**CITY OF SAINT PAUL
HERITAGE PRESERVATION COMMISSION STAFF REPORT**

FILE NAME: 2250 University Avenue
CURRENT ADDRESSES: 2250 University Ave. W, 2264 University Ave. W, 731 Hampden Ave.
APPLICANT: Brad Johnson, Raymond Station LLC
OWNER: Raymond Station LLC
PROJECT ARCHITECT: David Miller, UrbanWorks Architecture
DATE OF APPLICATION: March 1, 2019
DATE OF PUBLIC HEARING: March 25, 2019
HPC DISTRICT: University – Raymond Heritage Preservation District
PERIOD OF SIGNIFICANCE: 1891-1941
INVENTORY NUMBER: RA-SPC- 3940
CATEGORY: Non-Contributing **WARD:** 4 **DISTRICT COUNCIL:** 12
CLASSIFICATION: New Construction
BUILDING PERMIT #: N/A
STAFF INVESTIGATION AND REPORT: Allison Suhan
DATE: March 15, 2019

HPC APPLICATION

6 HAMPDEN AVENUE ELEVATION (EAST)
A301 3/32" = 1'-0"

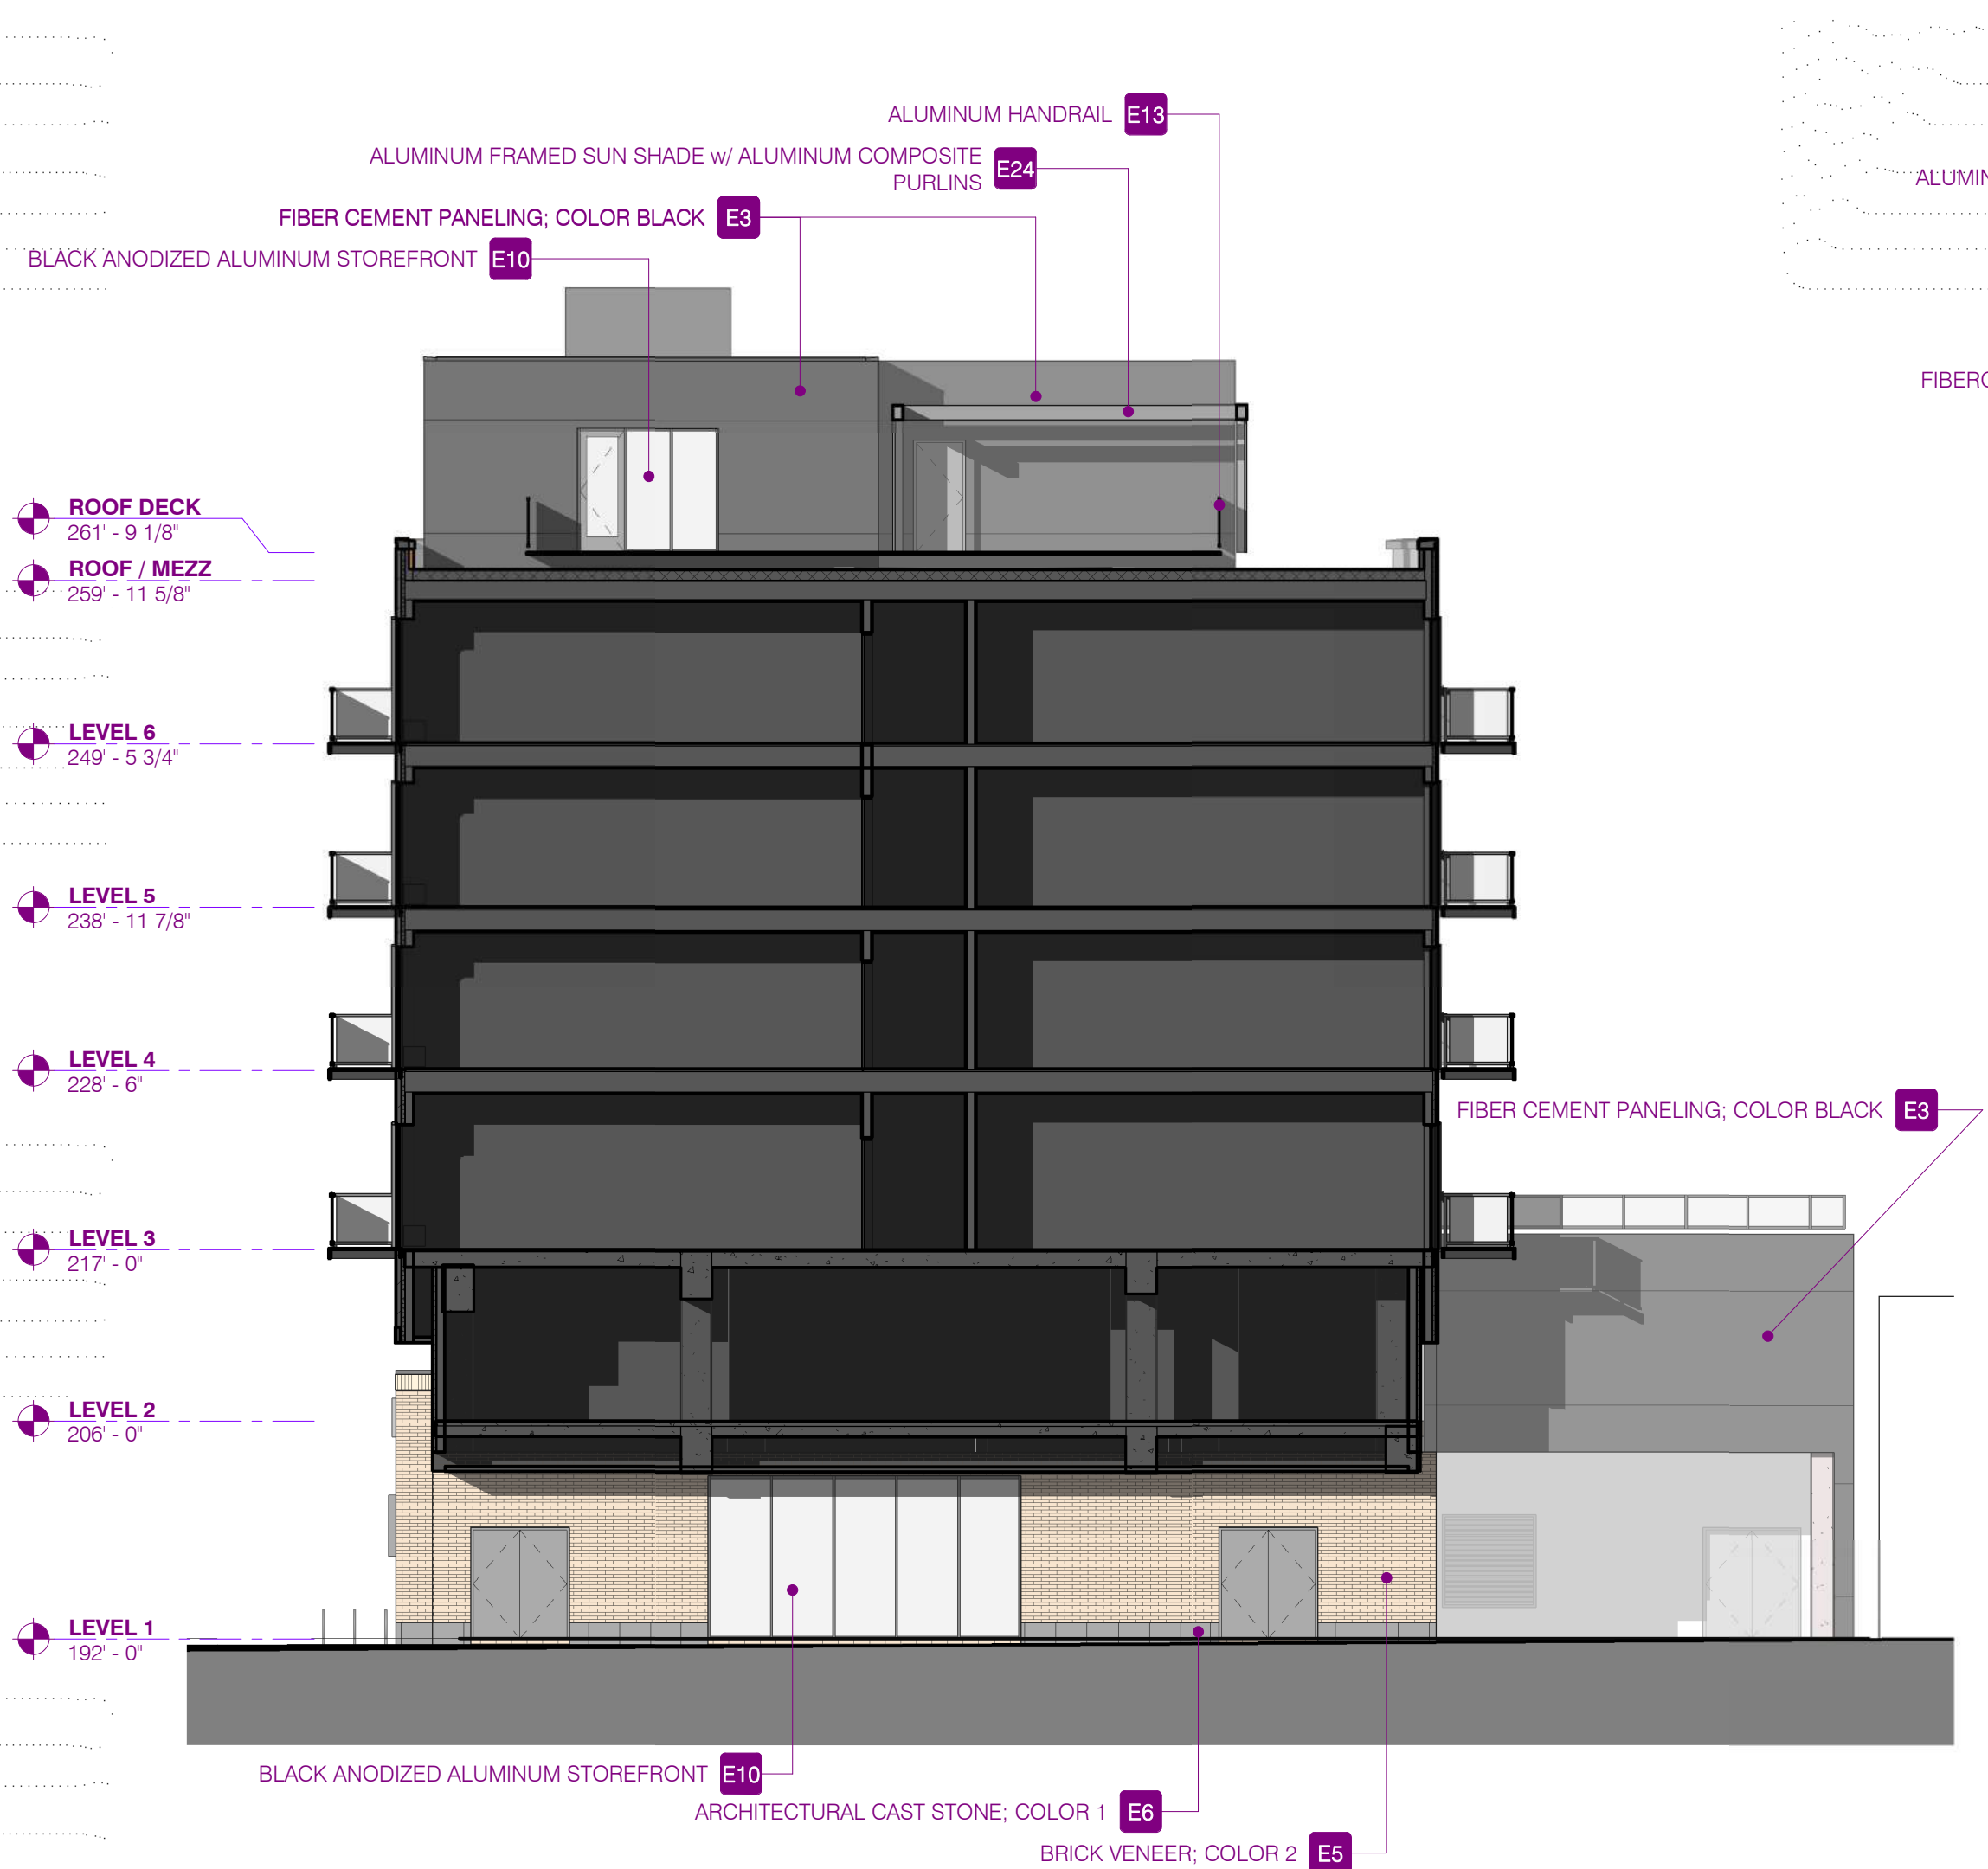
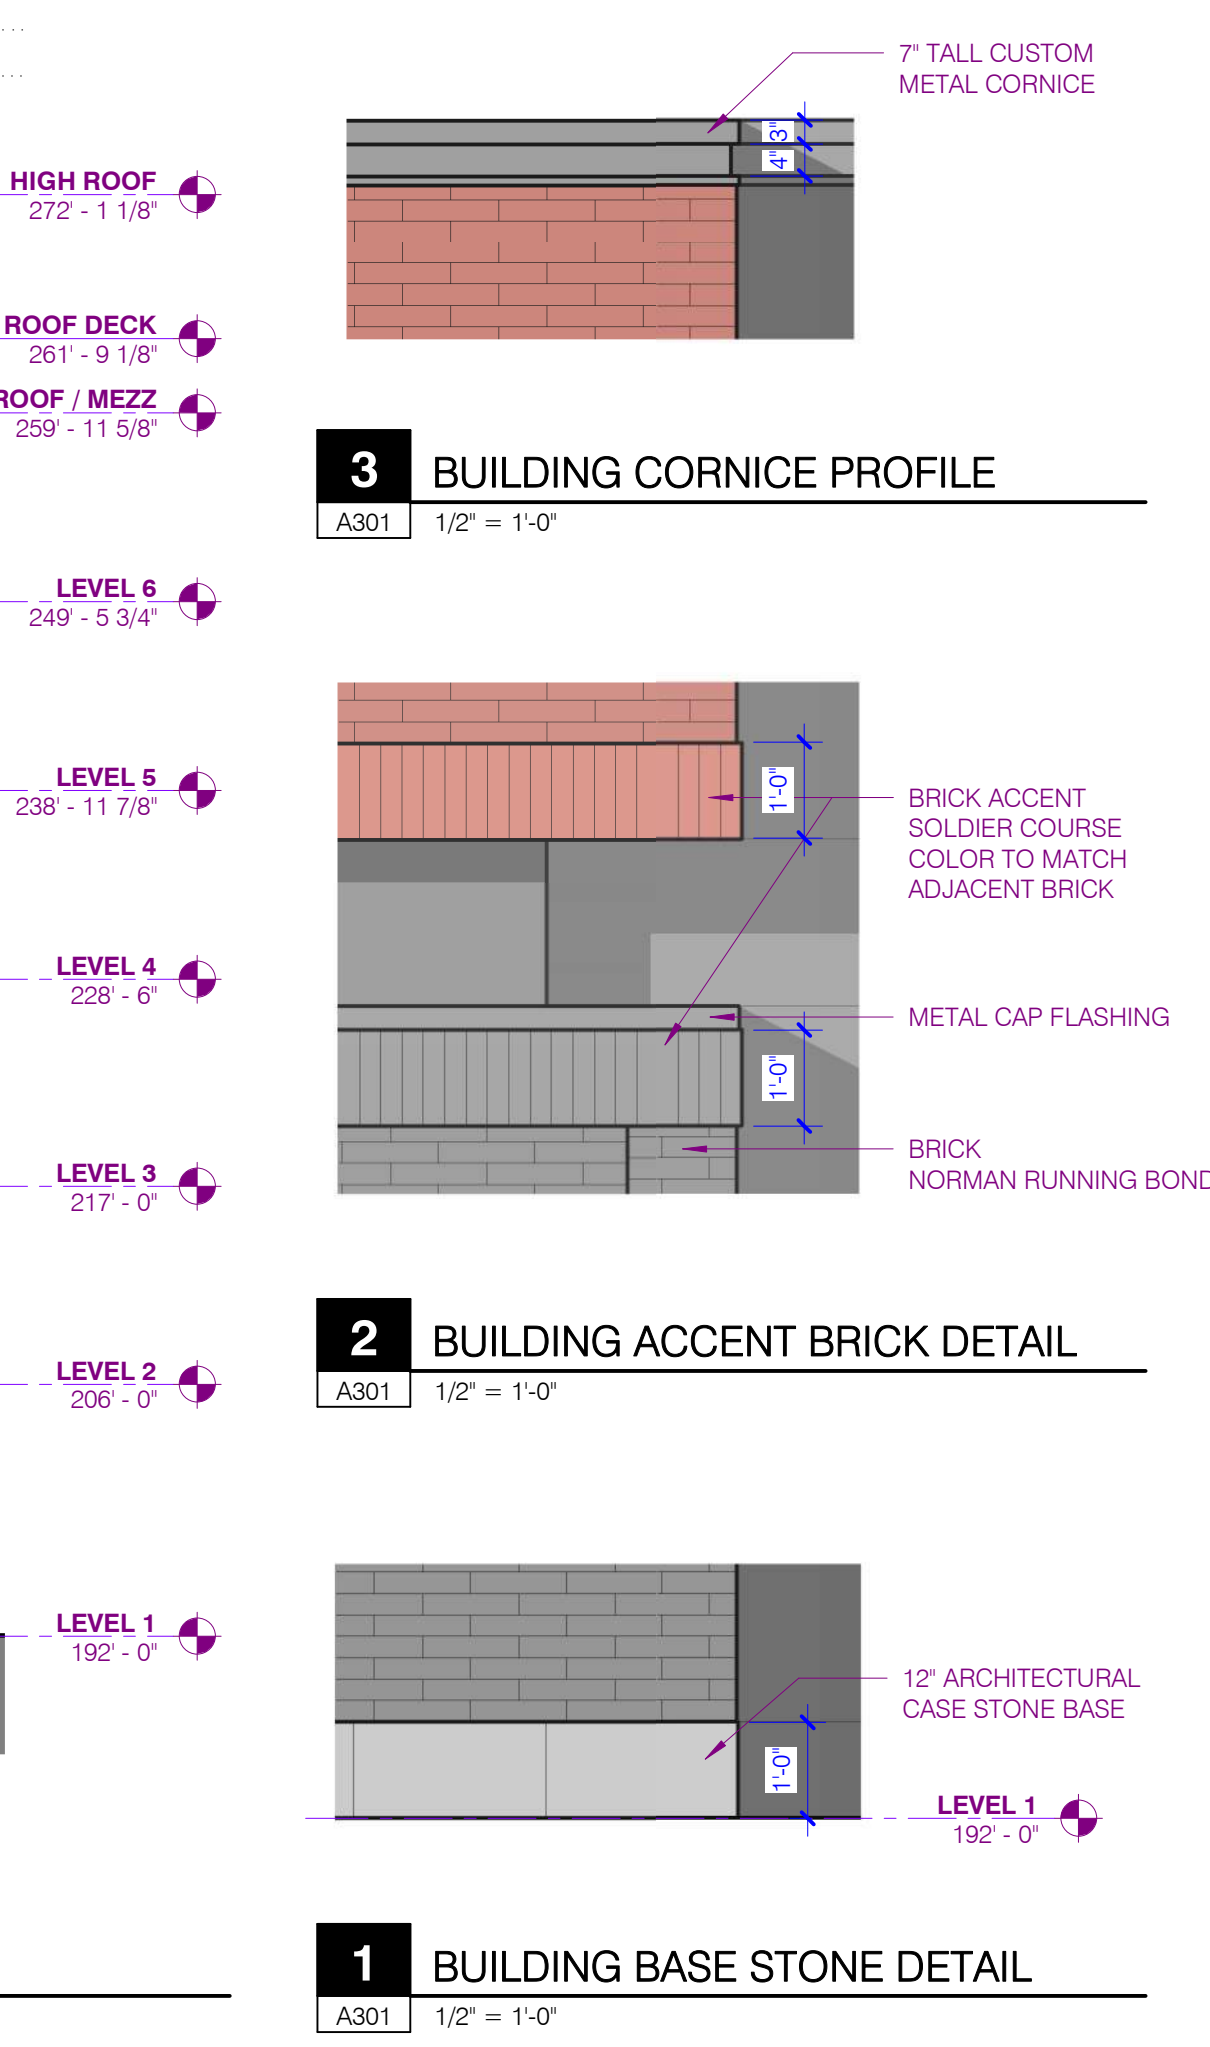
1. The balconies on the Hampton Avenue (East) elevation shall be inset to relate to the warehouse rhythm and context of the district.
2. The cornice shall match or exceed the dimensions of the break between the 1st level storefronts and the residential units.

3. All metal shall have a dark finish.
4. A bulkhead detail shall be included at the base of all storefront style windows.
5. The door, window and storefront glass shall be two-way and have no reflective, tinted, or mirrored qualities.

6. An alternative color that relates to the earthtones present in the district shall be explored for the black fiber cement panels, garage doors, and brick and be reviewed by an HPC Design Review Committee.
